Sicherheitsmitteilung SM 060602

Anweisungen für die Aufhebung vom Sprungverbot Reservefallschirm Techno240

Effective Date:	8 June 2006	
Compliance:	<p>Accomplish the following before the next use:</p> <ul style="list-style-type: none"> - replace the slider and the steering lines as defined by Service Bulletin BSV_06_001 and use only the packing method as defined by that Service Bulletin. 	
Ref. Publications:	Parachute de France BSV_06_001 dated 08/06/06 or later approved revisions.

PARACHUTES DE FRANCE 2 rue Denis Papin Jouy le Moutier 95031 Cergy Pontoise Tél. 33 1 34 32 77 77 Fax 33 1 34 32 73 17	<h2 style="margin: 0;">Service Bulletin</h2> <p style="margin: 0;">Title : Evolution of the TECHNO 240-B</p>	IGQ_MNG_MQL_004_ENR01 Version 1 du 17/01/06 BSV_06_001 Date: 08/06/06 Page 1/4
--	--	--

STEP A - STEERING LINES REPLACEMENT:

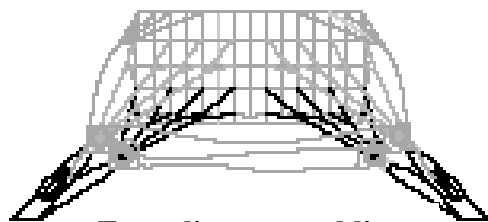
1) and 2) Cut the steering line of canopy at the specified point to remove main steering line from secondary

3) Connect the main steering line (P/N P2009030801) provided in the kit P/N: P2009052910 using a larkshead knot as specified.

4) Hold the larkshead knot tight.
Carry out same operations to the opposite steering line.

Front lines assembling

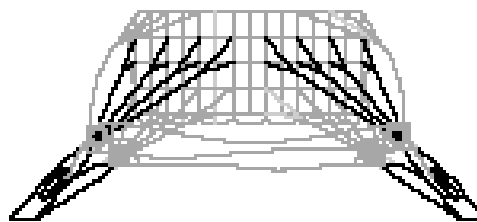
- 2) Connect the canopy to the rig.
- 3) Check the canopy connection to risers with the following drawing:

Steering lines assembling

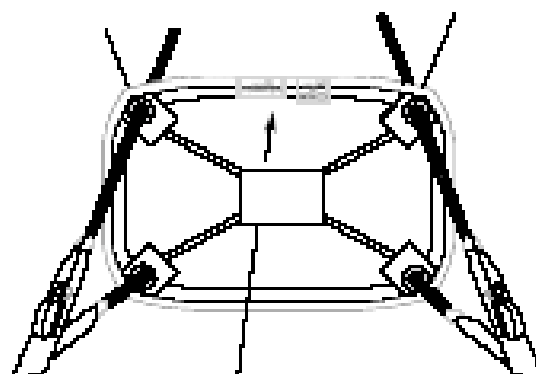
Check of slider position
The identification stamp shall be placed
between rear risers toward top direction.
(lower surface side)
